Project	IEEE 802.16 Broadband Wireless Access Working Group < http://ieee802.org/16 >	
Title	Figure 470, comment#62	
Date Submitted	2007-01-17	
Source(s)	Aik Chindapol, Achim Brandt Siemens Networks	Achim.brandt@siemens.com
Re:		
Abstract	Change to Figures 470, section 14.1.3, page 35 – in support of comment #62	
Purpose	Adoption	
Notice	This document has been prepared to assist IEEE 802.16. It is offered as a basis for discussion and is not binding on the contributing individual(s) or organization(s). The material in this document is subject to change in form and content after further study. The contributor(s) reserve(s) the right to add, amend or withdraw material contained herein.	
Release	The contributor grants a free, irrevocable license to the IEEE to incorporate material contained in this contribution, and any modifications thereof, in the creation of an IEEE Standards publication; to copyright in the IEEE's name any IEEE Standards publication even though it may include portions of this contribution; and at the IEEE's sole discretion to permit others to reproduce in whole or in part the resulting IEEE Standards publication. The contributor also acknowledges and accepts that

3 **Figure 470 – SAP Service primitive Flow Diagram Template. Four typical handshake scenarios shown here.**
 4 **The procedures are applicable to BS and MS side.**

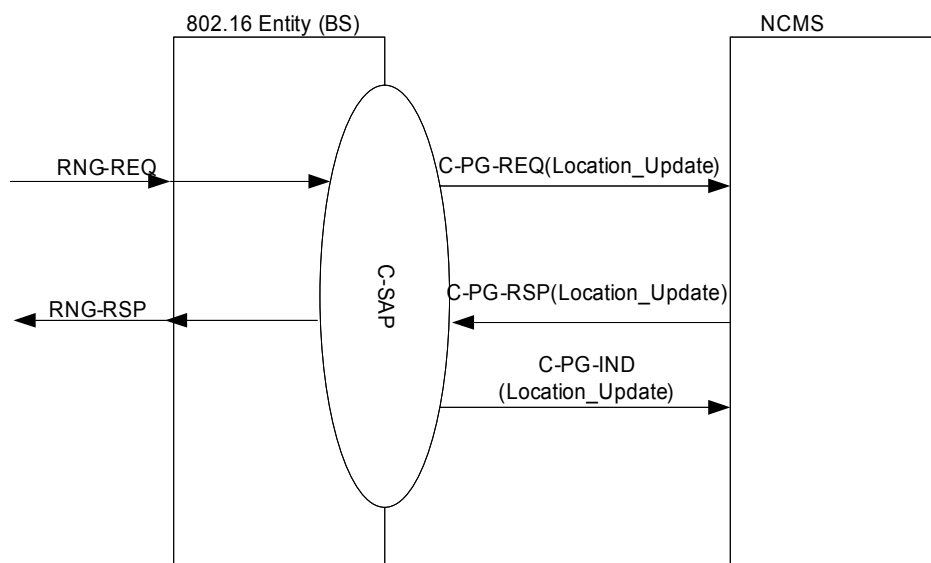
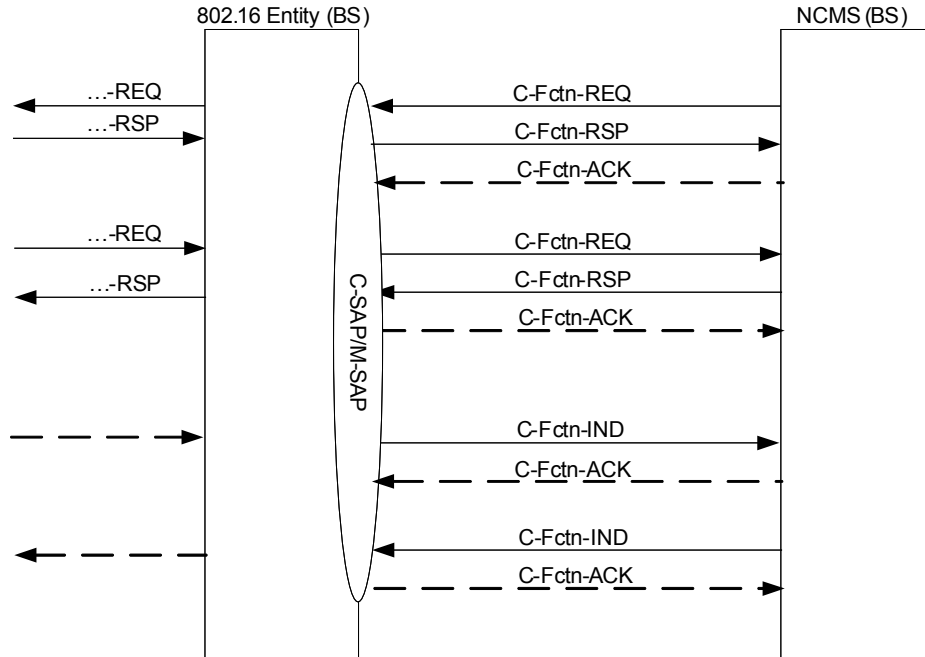
2 Figure 470, the SAP Service Flow Diagram Template, currently is not consistent with the way how the four primitive types
3 are used throughout section 14.2. E.g. the IND primitive is in fact used in both directions etc. Comment #62 therefore
4 proposes to update Figure 470. At the same time, comment #62 aimed at adopting the standard usage of service primitive
5 types REQ, RSP, IND, CFM as defined e.g. in IEEE 802.2. Since section 14 currently applies the primitive types differently,
6 the alignment of the primitive types to that of 802.2 would cause changes to all of section 14.

7 This contribution proposes a less radical change: It includes a proposed remedy for comment#62 which is in line with the
8 current usage of the primitives in section 14.2. The current primitive types REQ, RSP, IND and ACK are maintained. Some
9 text is proposed which states the underlying primitive design rules explicitly.

5 The figure is illustrative only and provides an example of correct formatting of primitive figures.

6 The figure illustrates the following rules underlying the usage of C-SAP and M-SAP Service Primitives:

- 7 1) A service primitive of type REQ is used whenever a response to the primitive is solicited. If there is a REQ
 8 message on the radio interface, it is generally mapped to a REQ on C-SAP/M-SAP.
 9 2) A service primitive of type RSP is used in response to a REQ primitive. Moreover, if there is a RSP
 10 message on the radio interface, it is generally mapped to a RSP on C-SAP/M-SAP.
 11 3) A service primitive of type IND is used at C-SAP or M-SAP for event notification if a response to this
 12 primitive is not solicited, and if the primitive is not sent in response to a REQ primitive.
 13 4) A service primitive of type ACK can be used to acknowledge the receipt of a C-SAP primitive of type
 14 REQ, RSP or IND.
